Nuro, Inc.; Receipt of Petition for Temporary Exemption for an Electric Vehicle With an Automated Driving System

ACTION: Notice of receipt of petition for temporary exemption; request for public comment.

SUMMARY: Nuro, Inc. (Nuro) has petitioned NHTSA for a temporary exemption from certain requirements in Federal Motor Vehicle Safety Standard (FMVSS) No. 500, which establishes standards for "Low-speed vehicles," on the basis that an exemption would make the development or field evaluation of a low-emission vehicle easier without unreasonably lowering the safety of that vehicle. The vehicle for which Nuro requests an exemption is a low-speed, highly automated delivery vehicle intended to be operated without any human occupants and thus designed without any seating. Specifically, Nuro requests exemptions from the requirements in FMVSS No. 500 that its vehicle be equipped with rearview mirrors, a windshield that complies with FMVSS No. 205, and a rear visibility (backup camera) system that complies with FMVSS No. 111. Nuro states that the absence of human occupants, combined with the vehicle's various safety design features, including the vehicle's Automated Driving System (ADS), ma

Figure 1. Picture of R2X (Source: <https://nuro.ai/product/>)

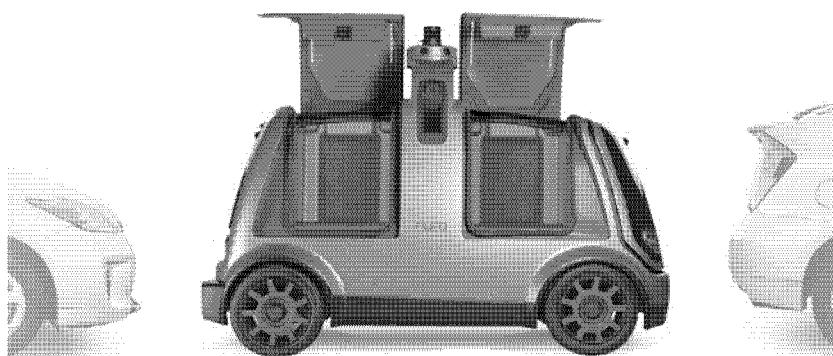
weight" is its unloaded weight, whereas a vehicle's GVWR is its loaded weight rating as specified by the manufacturer.) We note that Nuro does not provide the precise GVWR of the R2X, which is needed to determine whether the R2X would properly be classified as an LSV.

Finally, Nuro notes that, while the R2X would not be equipped with a windshield, the front of the vehicle would be equipped with a “plate” that resembles the appearance of a windshield. Nuro states that this design is intended to indicate to other road users the front of the vehicle, which would provide visual cues as to the R2X’s potential driving behavior, reducing confusion.

14. Did Nuro provide sufficient information about how the R2X would interact with human-controlled vehicles on the road? Should the agency be concerned about the front-end stiffness of the R2X and its impact on collision partners?

21. Would the pedestrian safety features described in the petition (rounded edges, pedestrian "crumple zones") be effective in the environment in which the R2X would be used? Can the effectiveness of these measures be validated? If so, should NHTSA require Nuro to provide testing data to demonstrate the effectiveness of these measures?
